DEVELOPMENT REVIEW COMMITTEE (DRC) COMMENT REPORT

PROJECT NAME: Fort Lauderdale Police Headquarters

CASE NUMBER: UDP-S21029

REQUEST: Site Plan Level IV Review: Public Purpose Use Request:
191,000 Square Foot Police Facility with Setback
Modification and Parking Reduction Request

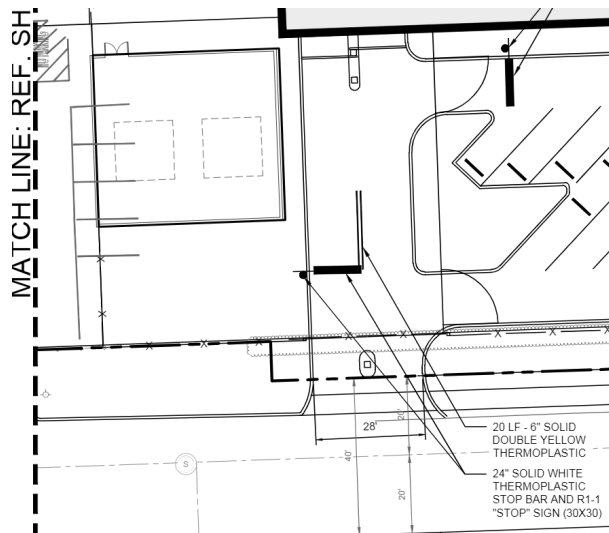
- k. Clarify if fence will divide confiscation parking area on pages PG-A2-01, CM-104 and LP-104 and if there is an opening. See clipped image below.
